LBNF

Modification since V4

Detector Mezzanine racks and cable trays

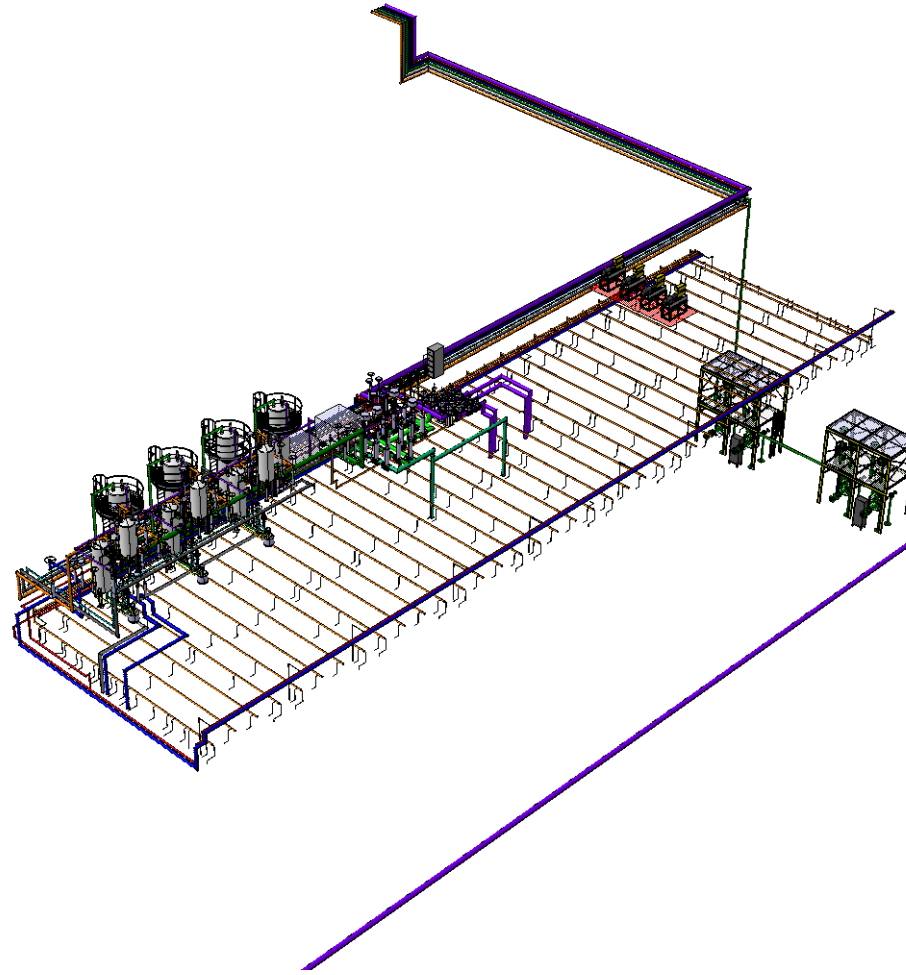
- Racks support position modified
- Detector mezzanine racks: number and dimensions have been changed

Mezzanine Proximity Cryogenics

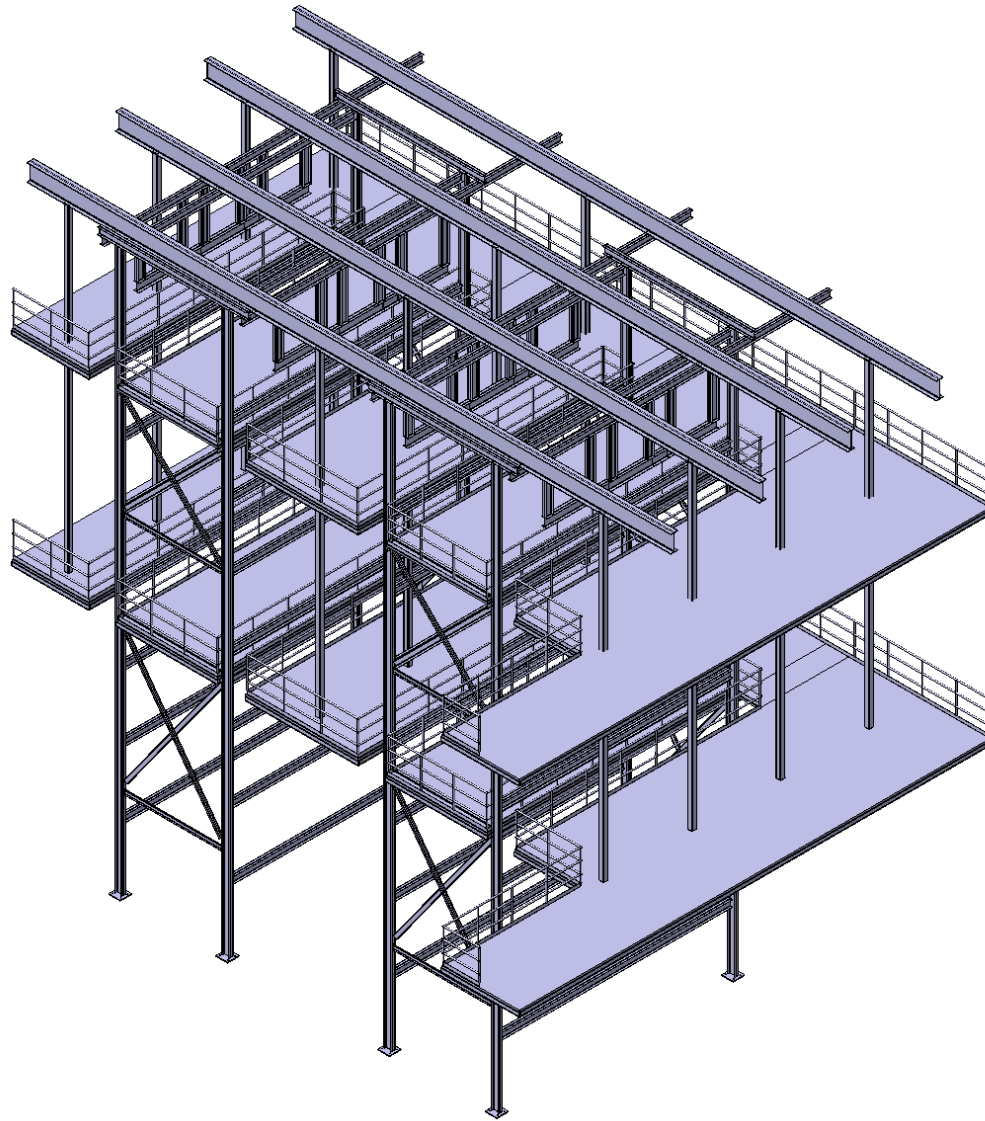
- Additional 4 x SPC 4 generators
- Additional lines on Purge Pipe system to reach condensers
- Layout modification on GAr lines, LAr transfer lines, N₂ Gas lines, N₂ liquid transfer lines and valve box system
- 1 of 4 cryo modules has been removed (LN₂ Phase Separator, LAr Condenser pump, New Condenser and *Desuperheater*)

Clean Room Structure

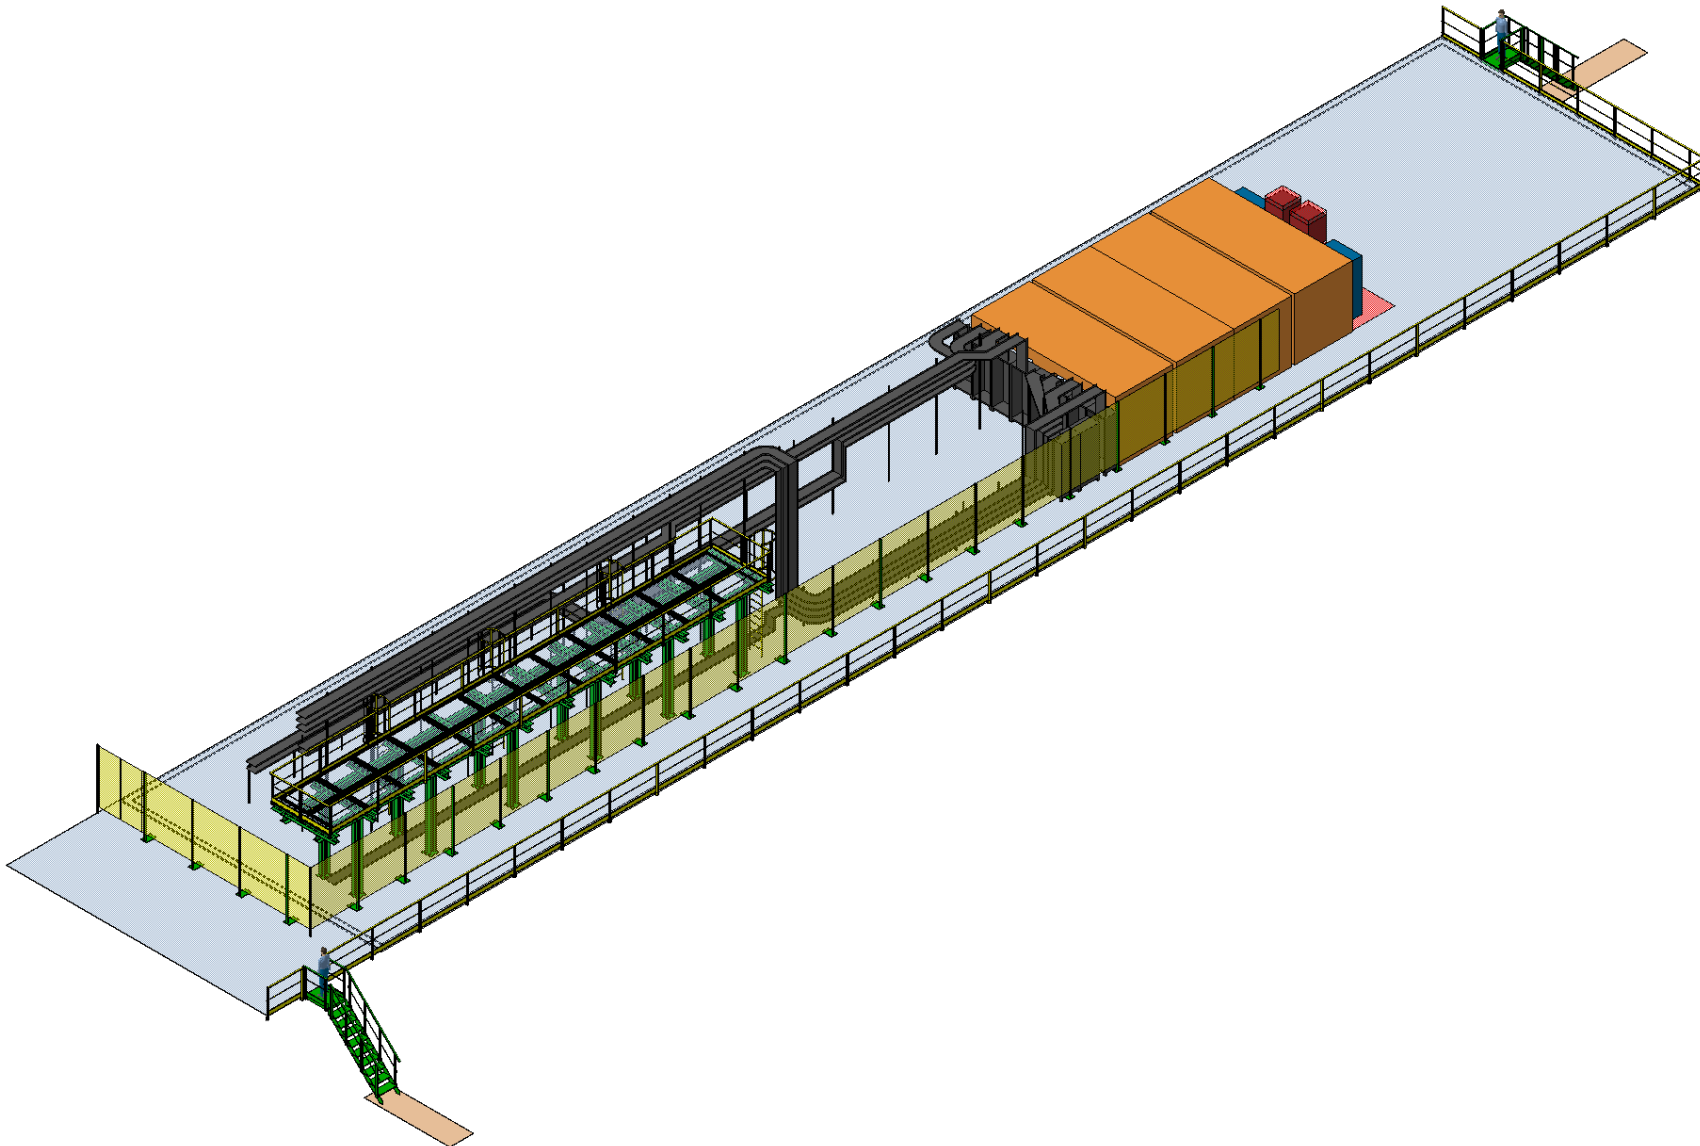
- Additional Clean Room Structure in front of the cryostat

Mezzanine Platform and Access

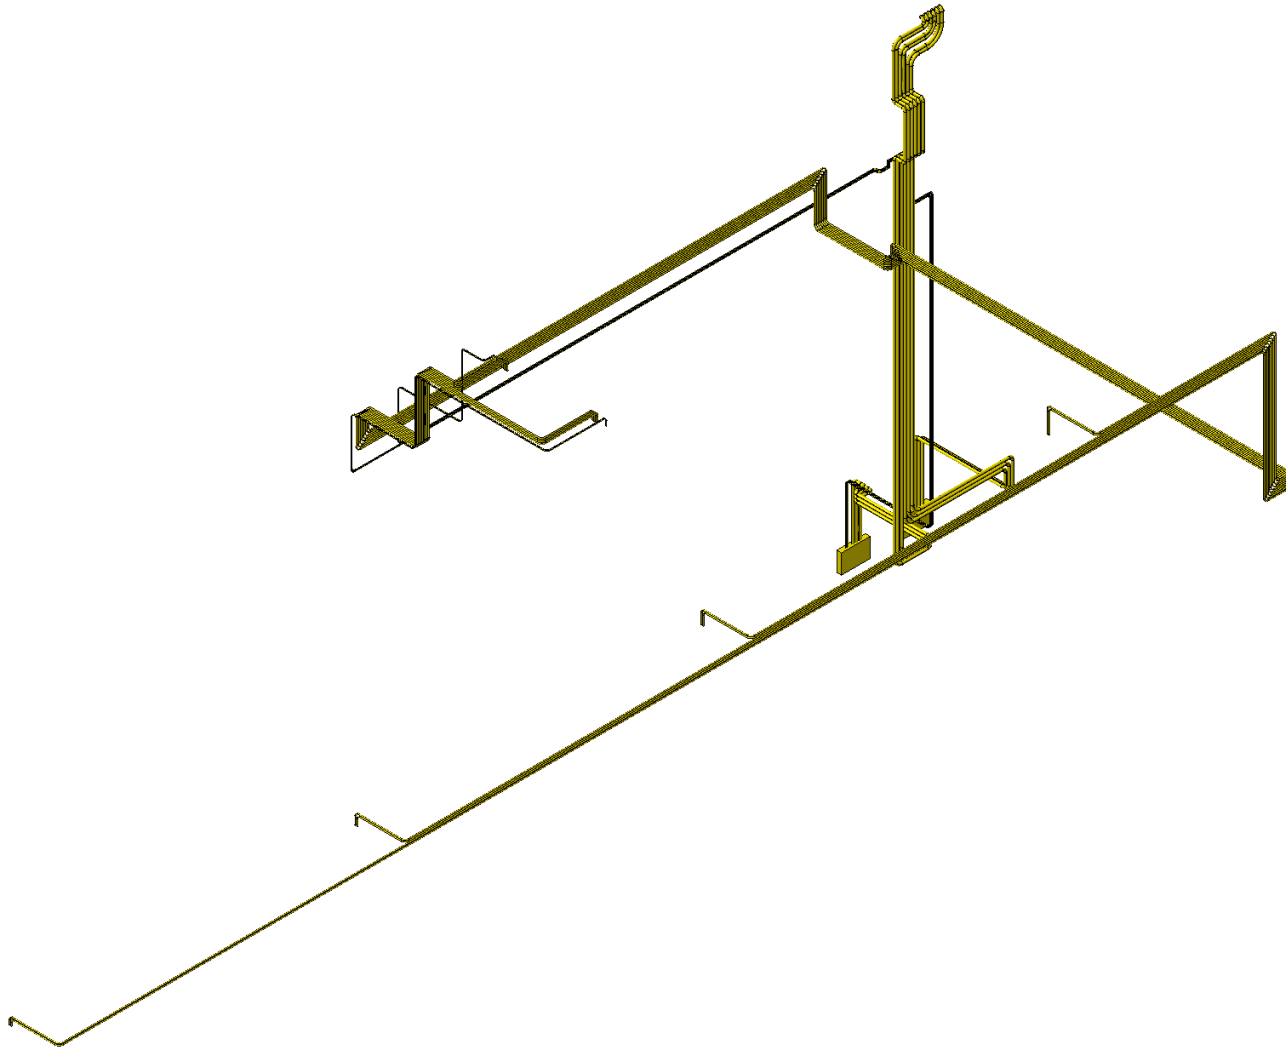
- Offices and racks moved to have more free space on front mezzanine

Additional Electrical Equipment

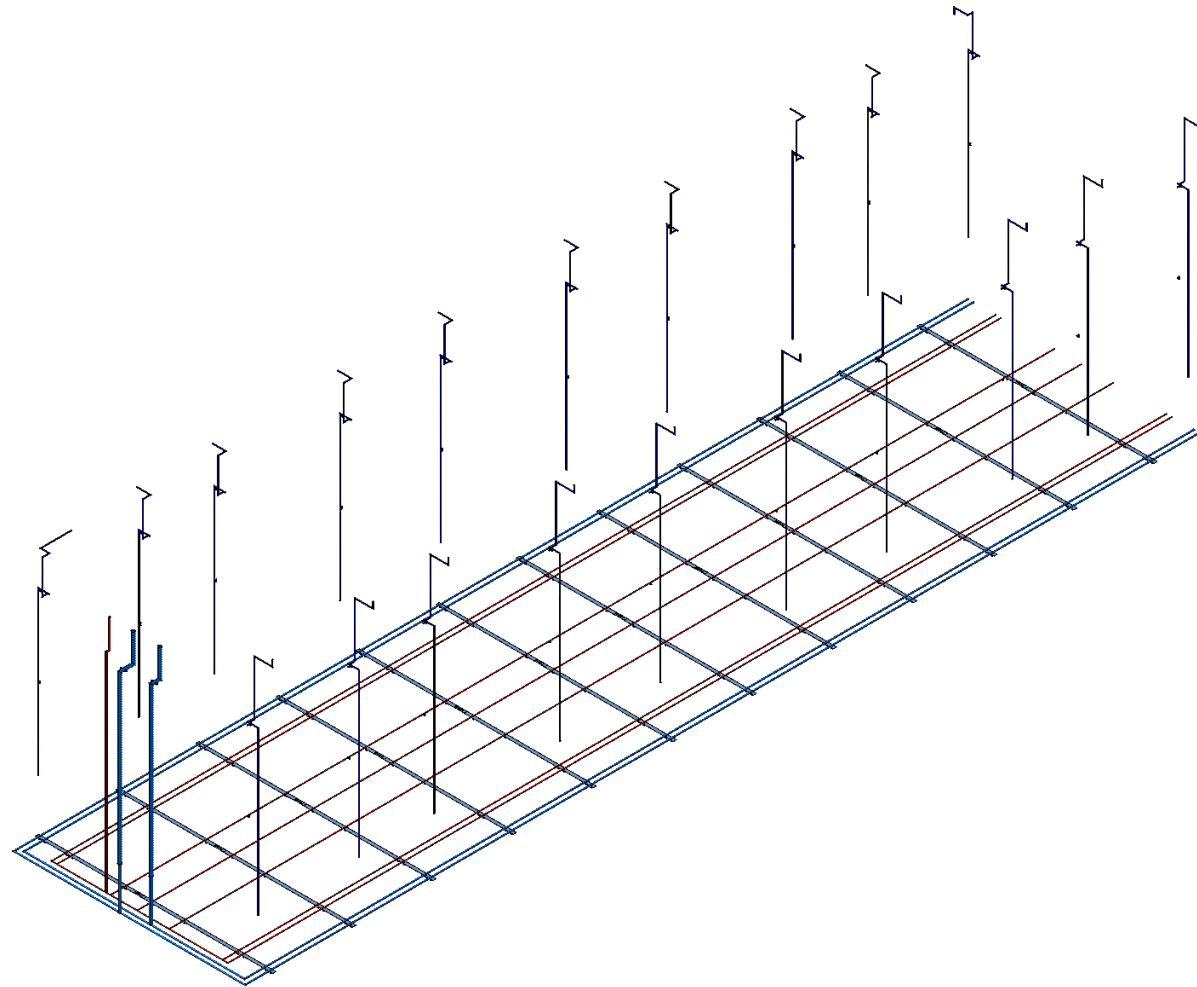
- Additional electrical equipment conduits (connecting the racks behind offices to the racks on the detector mezzanine)

Internal Cryogenics

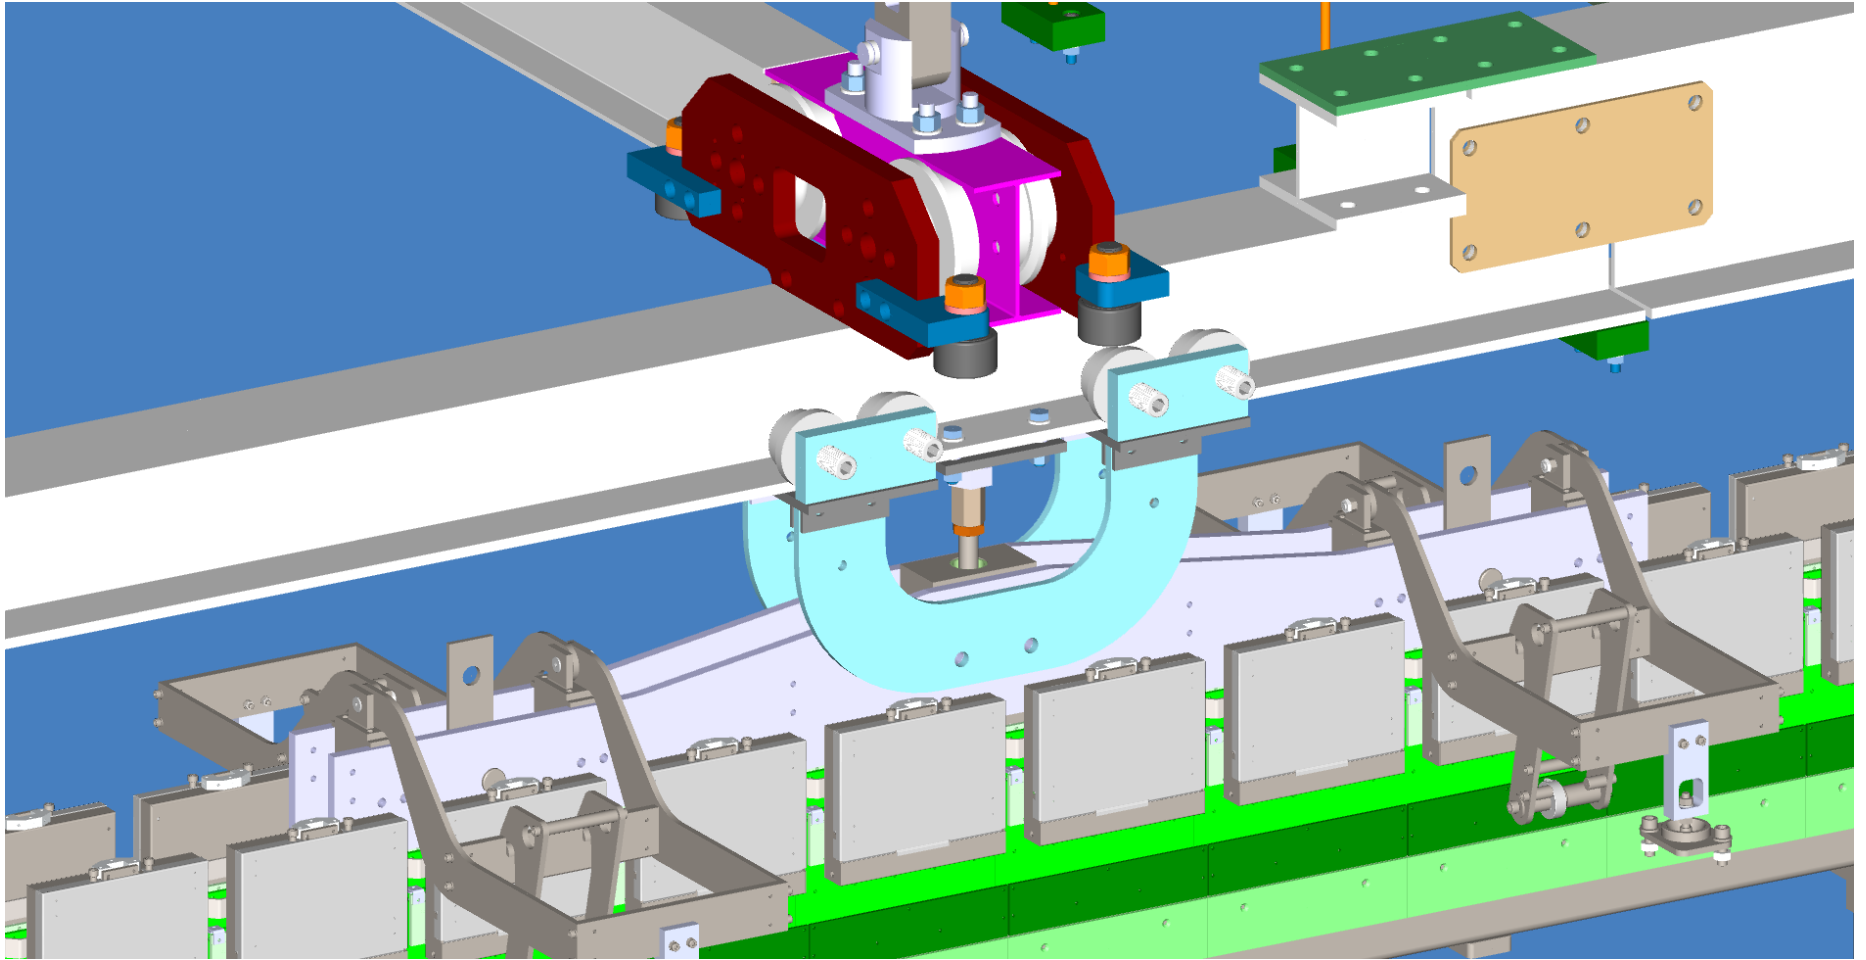
- Complete new layout for the cool down pipes (to avoid interference with the detector)

DSS

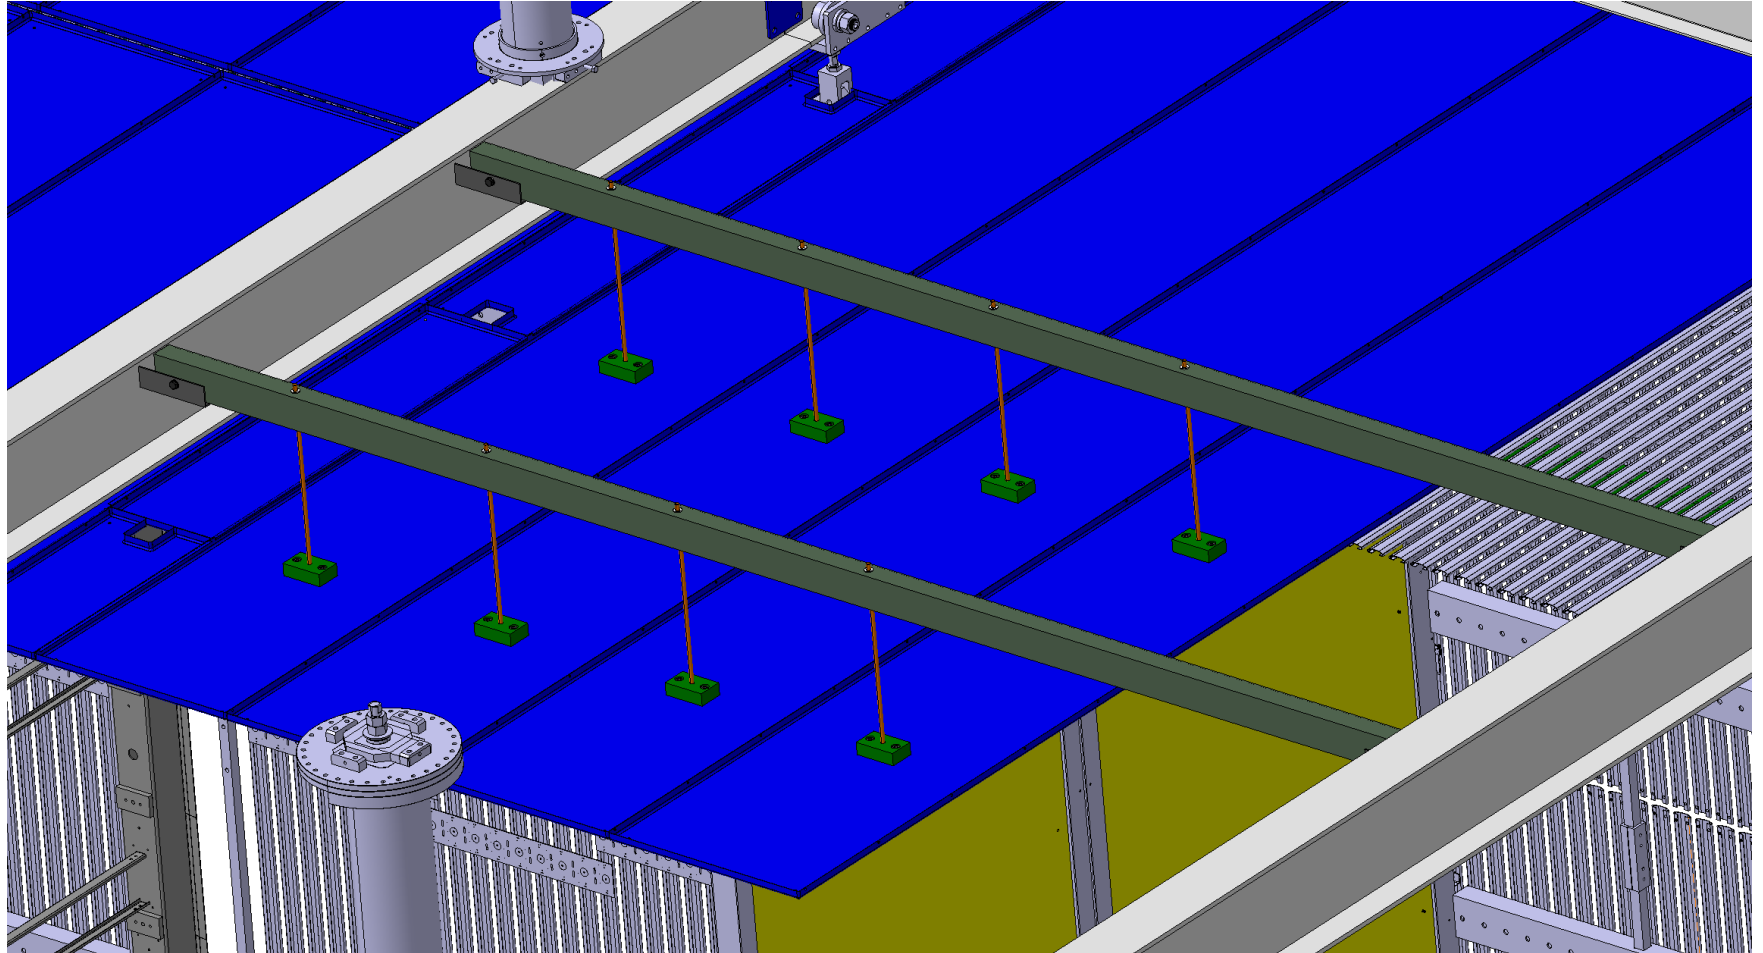
- New Trolley
- New Yoke-to-DSS connection
- New DSS rail-to-DSS rail connection
- New Feedthrough-to-DSS rail connection
